ILLINOIS POWER COMPANY

Subject: Illinois Power (IP) Company Request for  
Concurrence to Remove Additional  
Commodities from the Overinspection Program

ENCLOSURE 1  
TECHNICAL JUSTIFICATION FOR IP'S REQUEST  
FOR NRC CONCURRENCE TO TERMINATE  
THE OVERINSPECTION PROGRAM FOR  
ADDITIONAL COMMODITIES

ILLINOIS POWER RESPONSE TO NRC QUESTIONS  
IN ENCLOSURE 3 TO NRC'S APRIL 11, 1985, LETTER  
CONCERNING REQUESTS TO TERMINATE THE OVER INSPECTION PROGRAM  
FOR COMMODITIES OTHER THAN PIPING AND MECHANICAL SUPPORTS

FIGURE 1

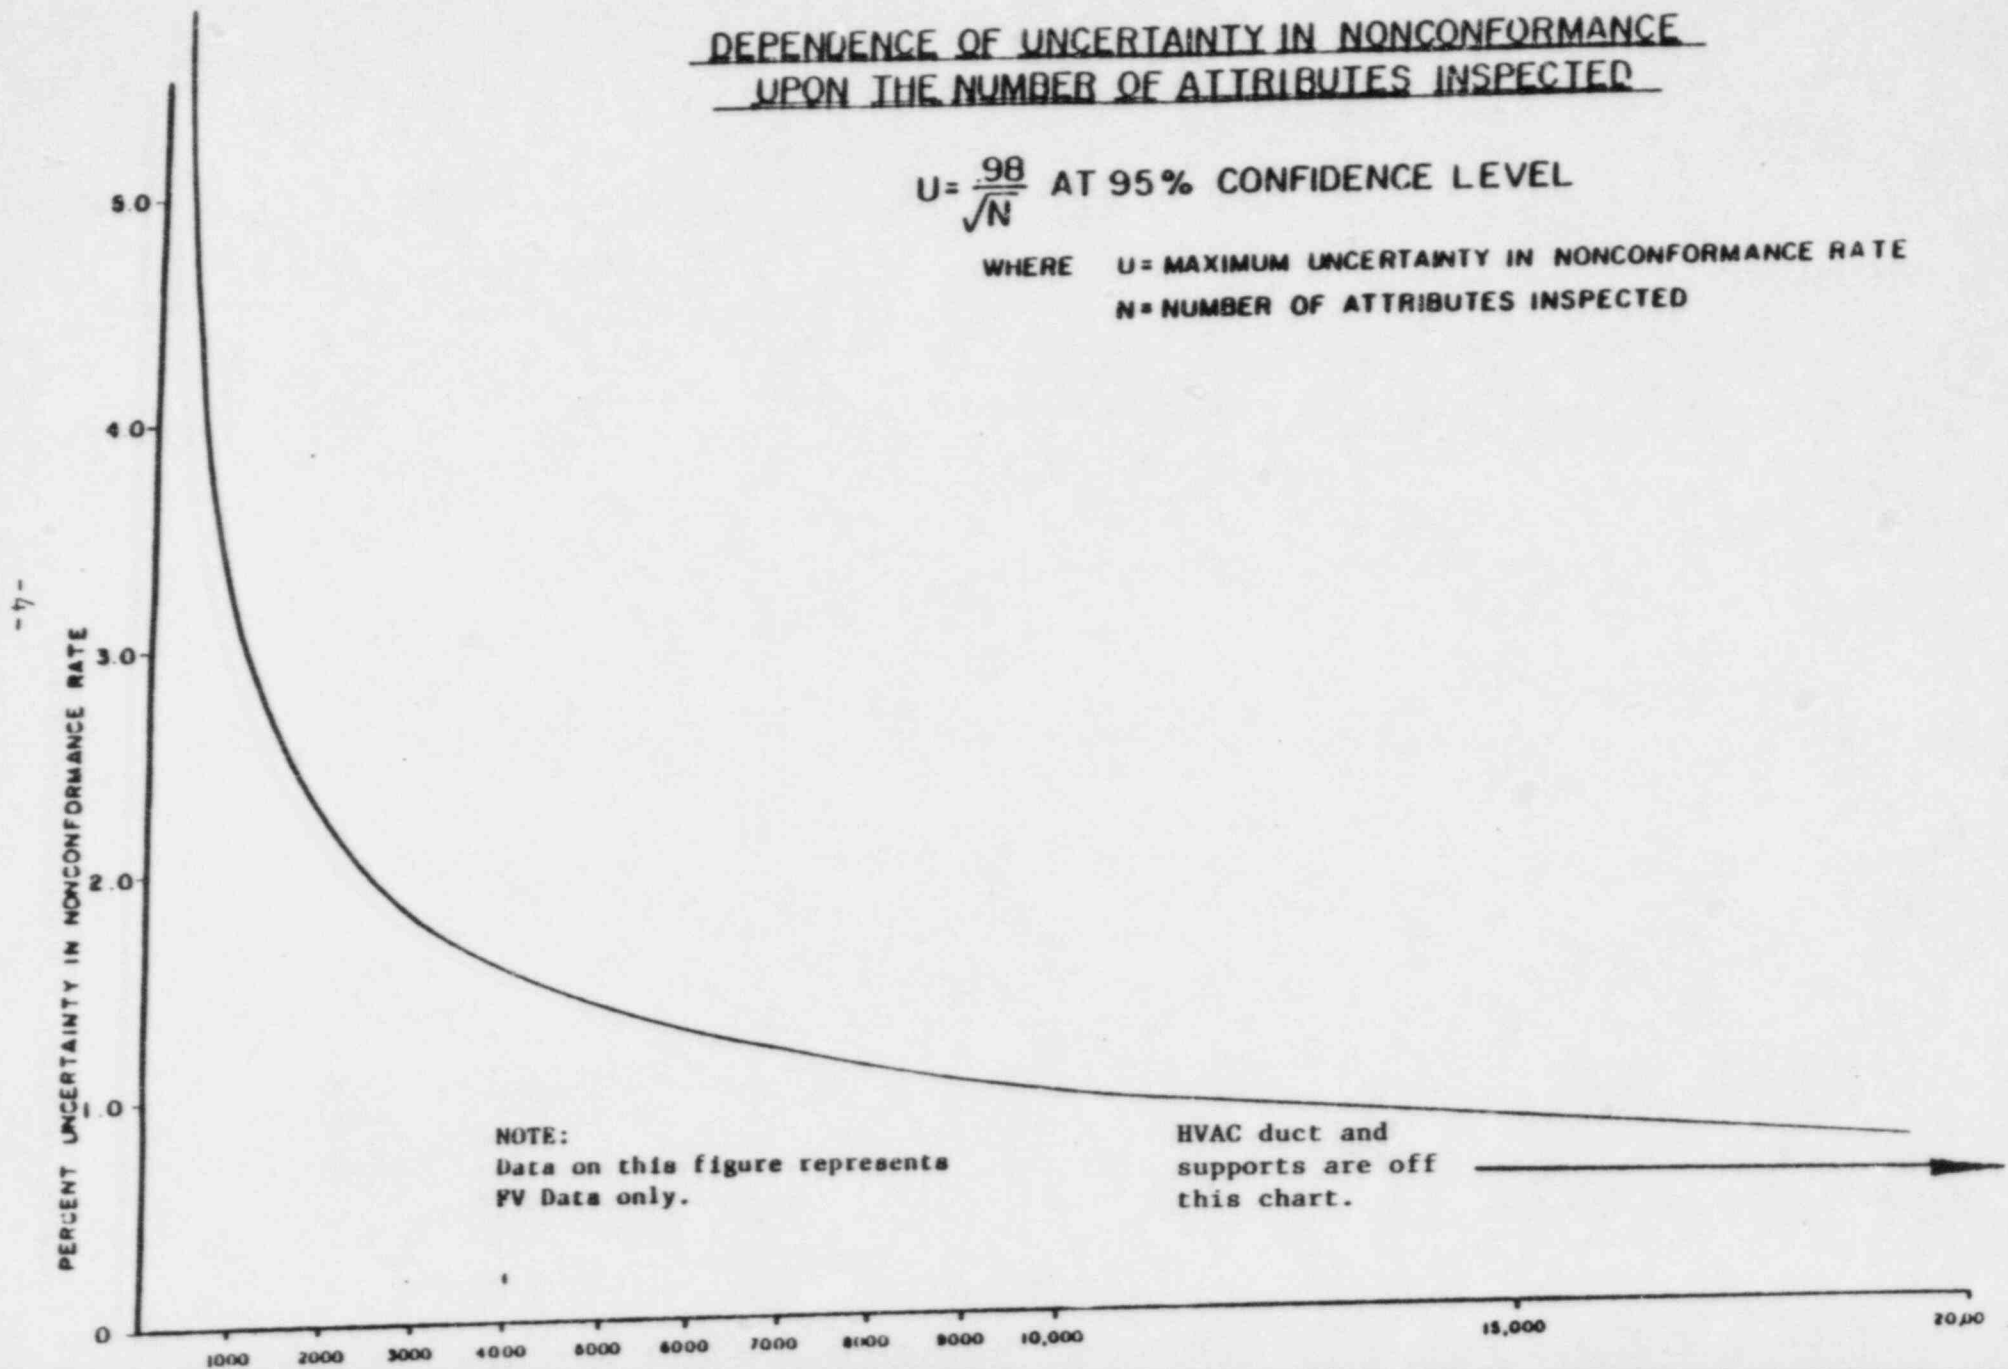
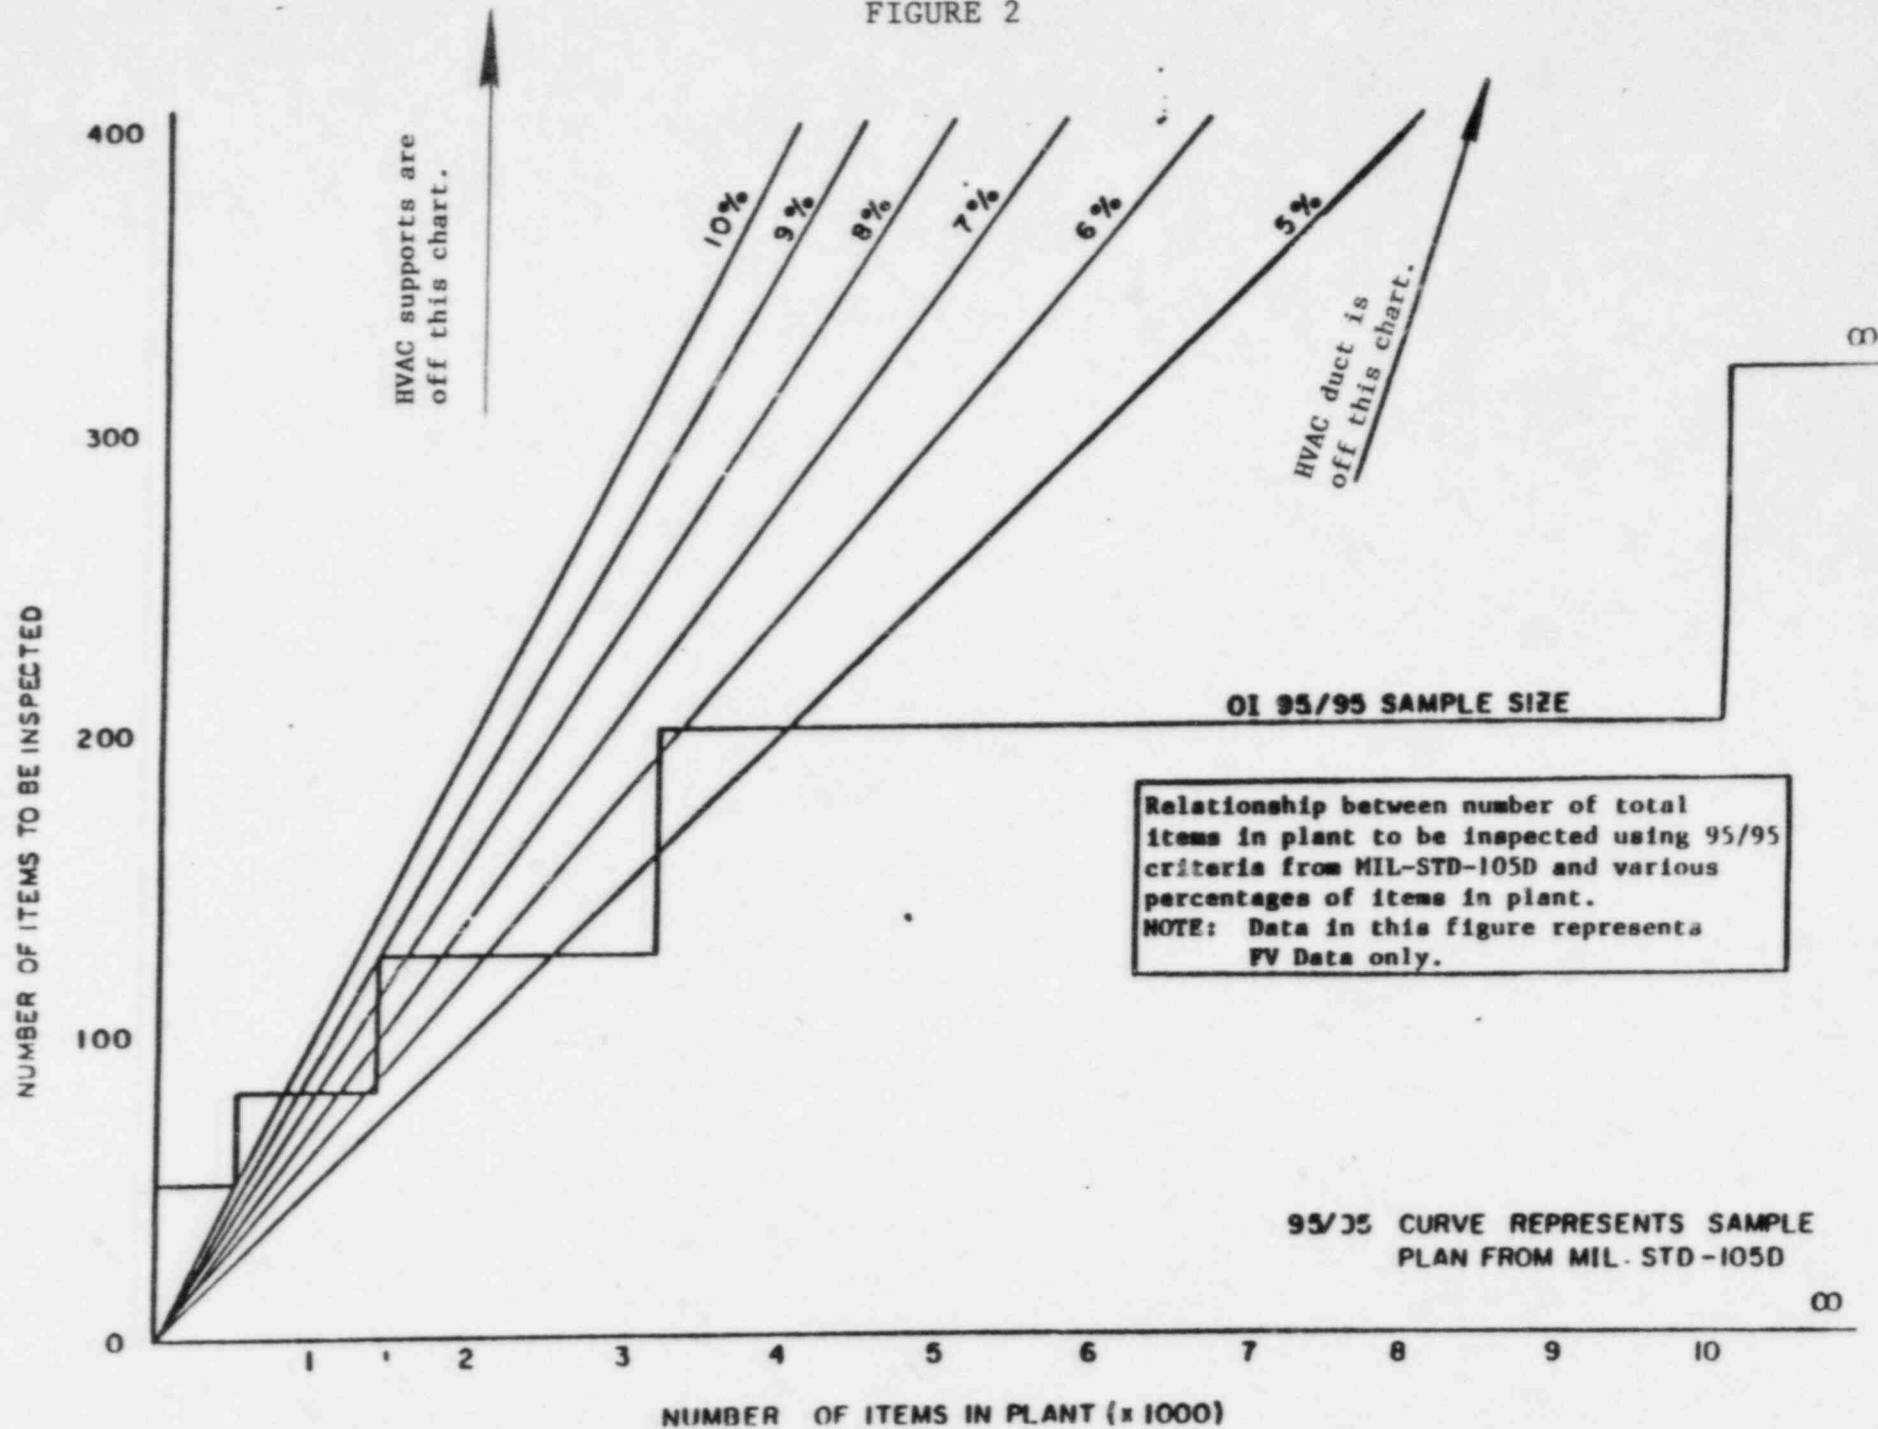
Based on the number of attributes inspected for each commodity, Figure 1 shows that the uncertainty associated with the reinspections are low, and further inspections are not expected to significantly reduce this uncertainty. In addition, Figure 2 shows that the 95/95 criterion, which is the basis for Overinspection Program sample inspection, is also satisfied for HVAC duct and duct supports.
